February 29, 2012

ENERGY STAR – version 2.0 – DRAFT 1 – Comments

**Chart 1:**

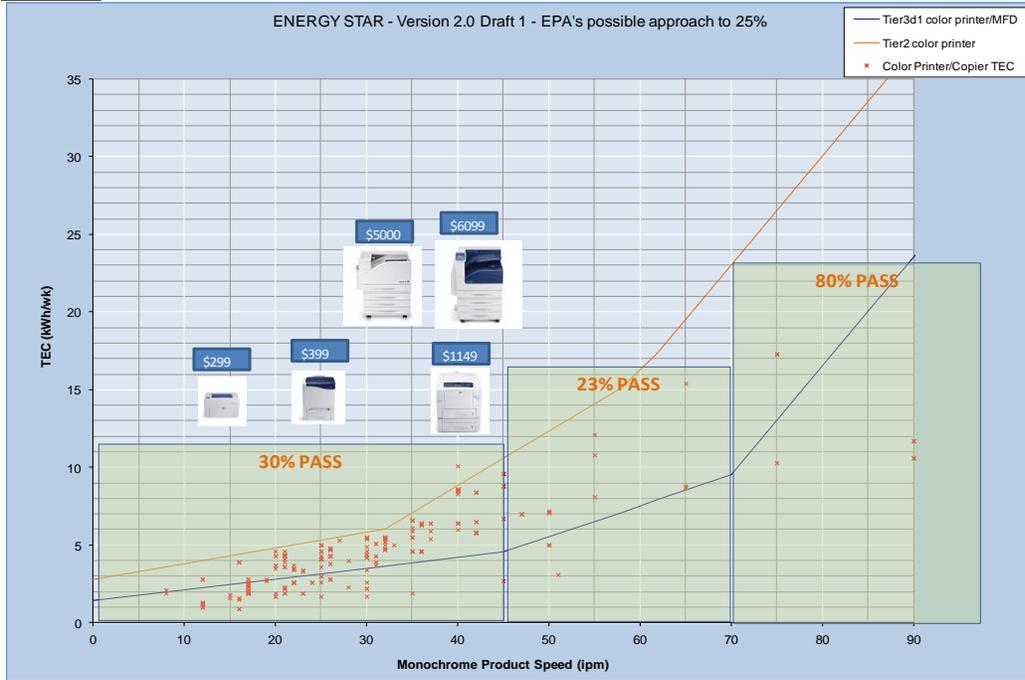
- As Chart 1 indicates, it appears that EPA may have set the draft 1 TEC limit based on the 0-44ipm speed range. By using such a large range of products to determine the 25% passing rate for non-MFD products, the draft specification unfairly treats the middle speed band of products (25-55ipm). Chart 2 illustrates that in the 25-55ipm range; only 15% of the products will pass the draft 1 specification. One of the reasons why we do not think the EPA can use such a large speed band grouping to determine the 25% is because between 0-44ipm there multiple market segments covered: personal, small and home office, small workteam, and workgroup – see Chart 2. These varied market segments have very different product requirements and feature sets which range from basic to complex. The more complex features will require more power and the data reflects this increase in the 35-55 speed ranges. As such, we suggest the EPA separate the low-end market segment products from the mid-higher-end office market segment when determining the 25% limit.

**Chart 3:**

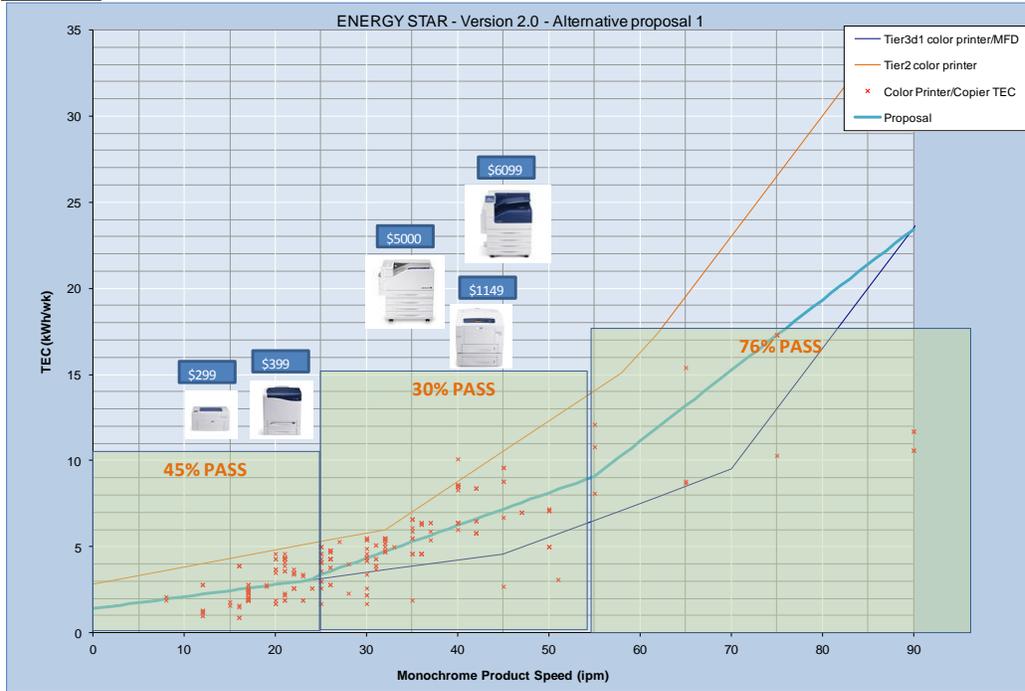
- Chart 3 provides a suggested non-MFD TEC limit that would separate the personal/small and home office (0-24ipm) and the small workteam/workgroup (25-55ipm) products and therefore fairly treat the 25-55ipm products.

Monochrome Product Speed, s, as Calculated in the Test Method (ipm)	TEC max (kWh, to the nearest 0.1 kWh)
Color non-MFDs	$s \leq 24$	$(s \times 0.07) + 1.4$
	$24 < s \leq 55$	$(s \times 0.19) - 1.37$
	$55 < s$	$(s \times 0.41) - 13.47$
